# DEPARTMENT OF HOUSING AND URBAN DEVELOPMENT

## Fair Housing Accessibility Guidelines Final Guidelines

**ACTION:** Notice of Adoption of Fair Housing Accessibility Guidelines -- Final Guidelines.

(a) Forward Reach Limit

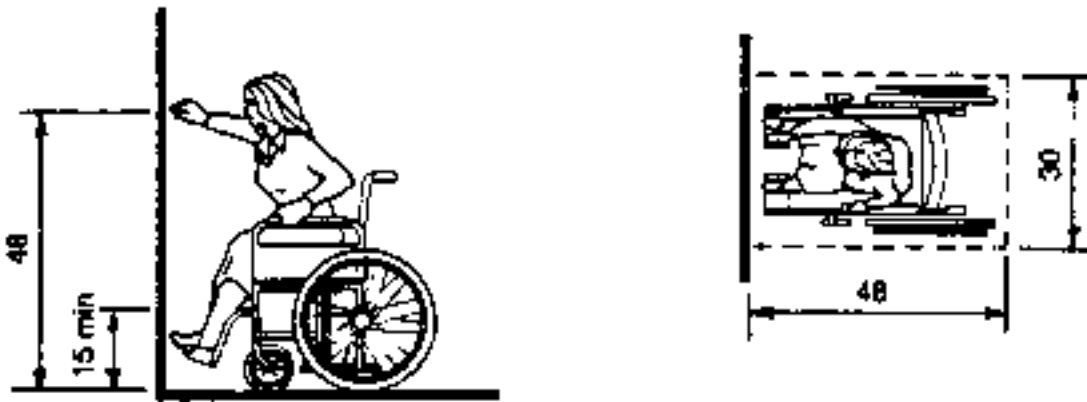
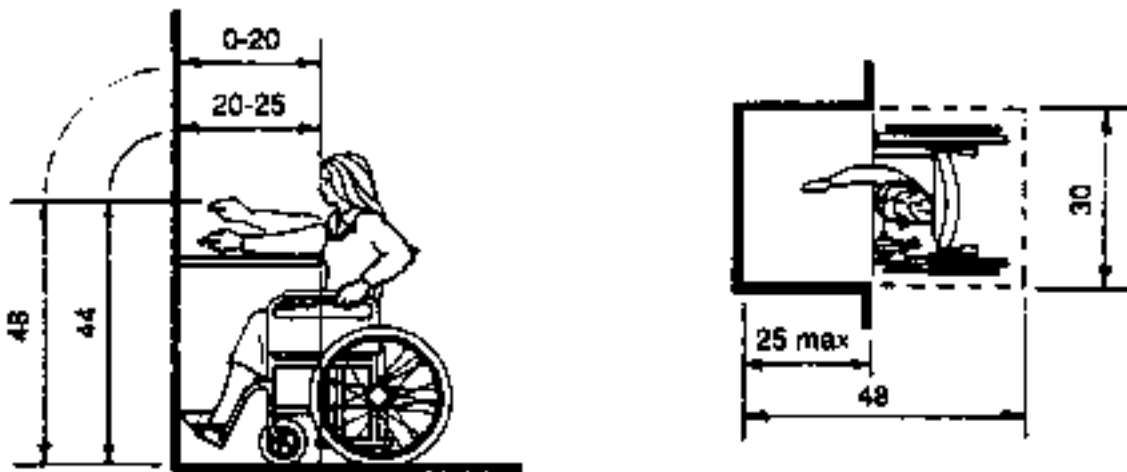
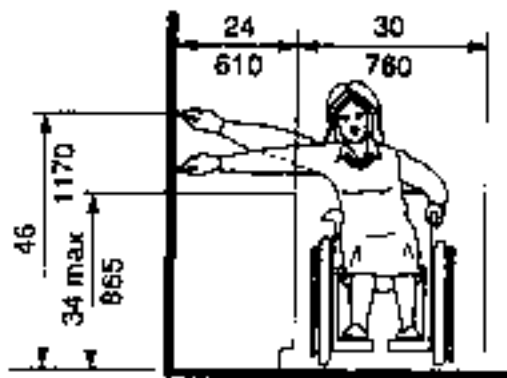
**Comment.** One commenter stated that Figure 3 in the proposed guidelines (Figure 2 in the final Guidelines) specifies a reach requirement more stringent than the ANSI Standard.

The proposed guidelines specified only the heights for forward reach, because those heights also are usable in side approach. The diagram in Figure 2 (formerly Figure 3) showing forward reach is identical to that of Figure 5 in the ANSI Standard. The ANSI Standard also includes a figure (Figure 6) for side reach that permits higher placement. The reach range for forward approach was the only one referenced in the proposed guidelines for use in the dwelling unit, because it was considered simpler and easier to use a single specification that would work in all situations. The reach range for forward approach has been retained in the final Guidelines for situations where there is no built-in obstruction in order to assure usability when the unit was furnished. However,

Fig. 8 Alternative Specification - Clear Floor Space at Bathtub

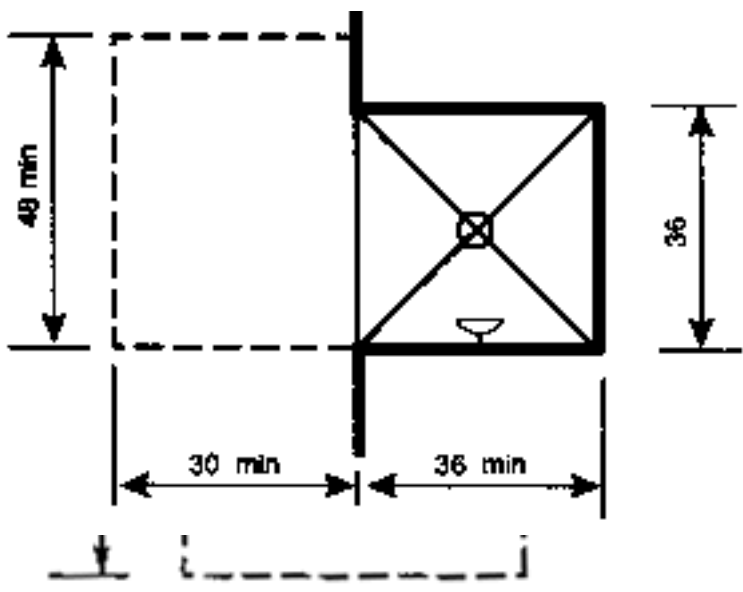
**Comment.** A number of commenters from the disability community stated that two of the six bathroom drawings in the preamble to the proposed guidelines (numbers 4 and 6 at 55 FR 24374-24375) did not allow for a parallel approach to the tub. These commenters requested that these drawings be removed from the final Guidelines. Other commenters stated that the Department's bathroom design illustrations at 55 FR 24374-24375 are not consistent with the Figure 8 bathroom design illustrations at 55 FR 24401.
